Rembrandt Homes 2081 Wallingford Ave

Site Plan Amendment Application
March 23, 2015

Application and Reason for a Change

Rembrandt Preferred Fence

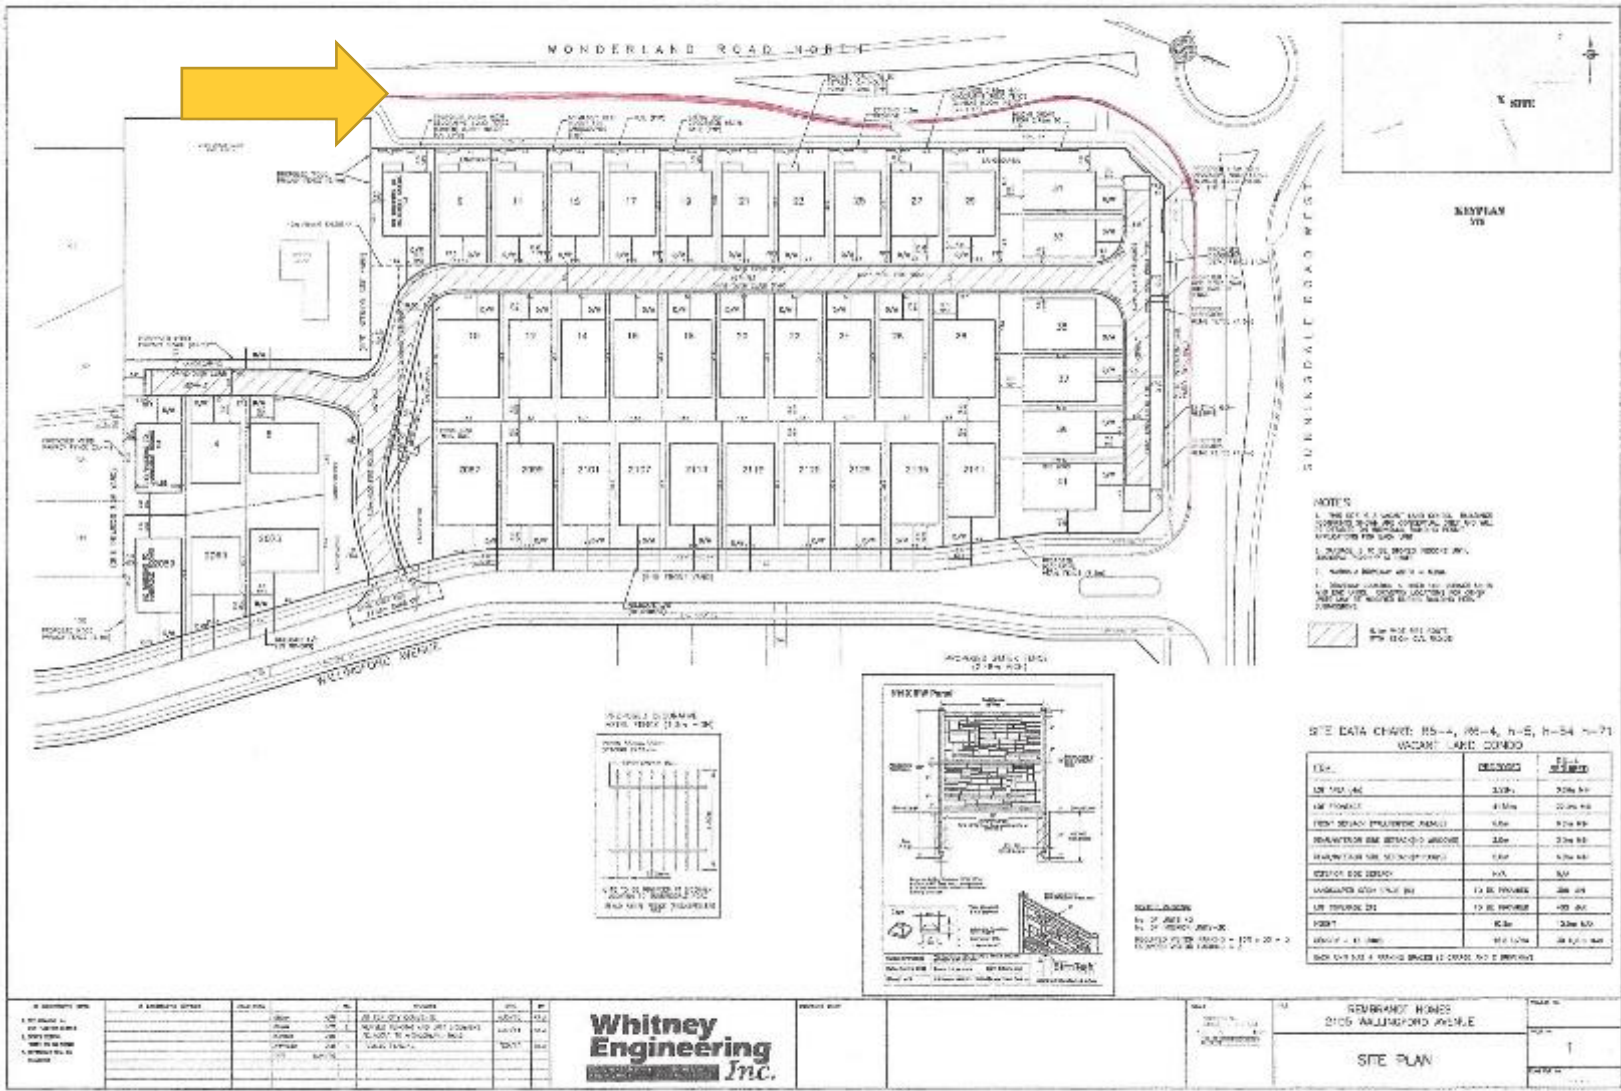
Rembrandt's Preferred Fence Design

- 2.4m height provides the required visual barrier – addresses the major reason why no sales
- The vegetative insets will provide softer relief along the fence
- Consistent with the solid fencing used within the Sunningdale subdivision
- Maximum security option
- Provides modest noise attenuation for others during build out
- Provides the best option to succeed in selling units

Two Initial Fence Options

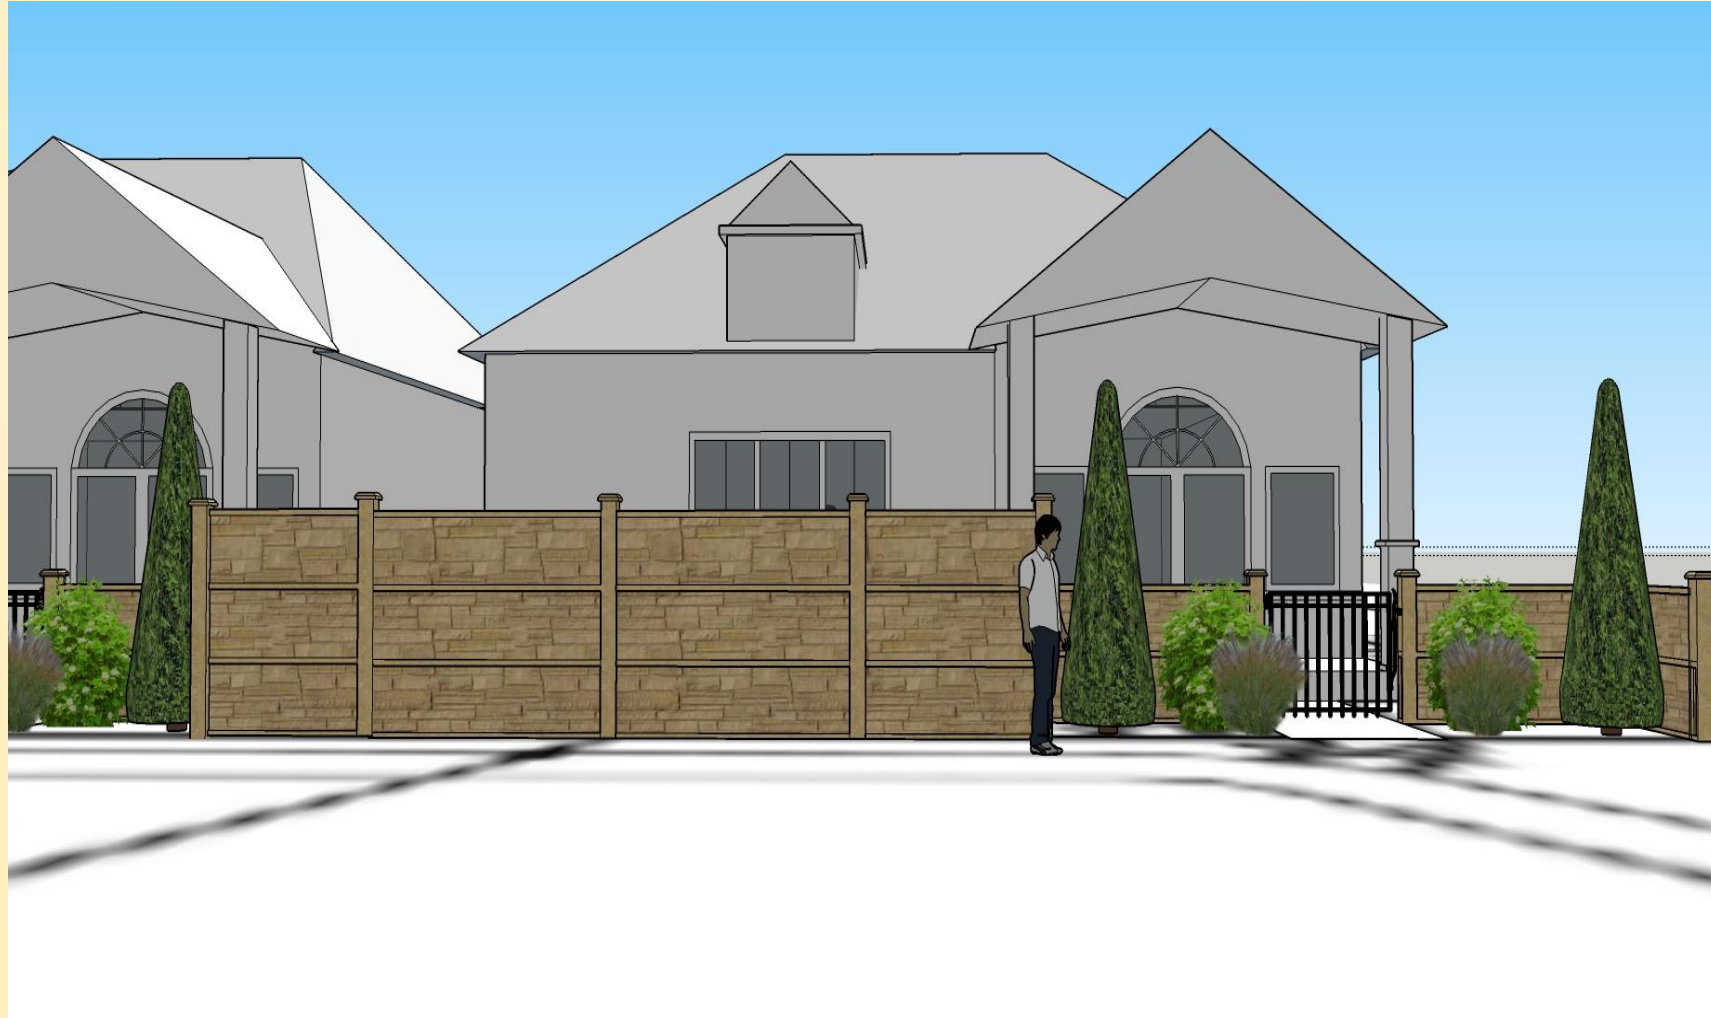
Rembrandt Preference -no gates

Reply as a City Suggestion

City Fence
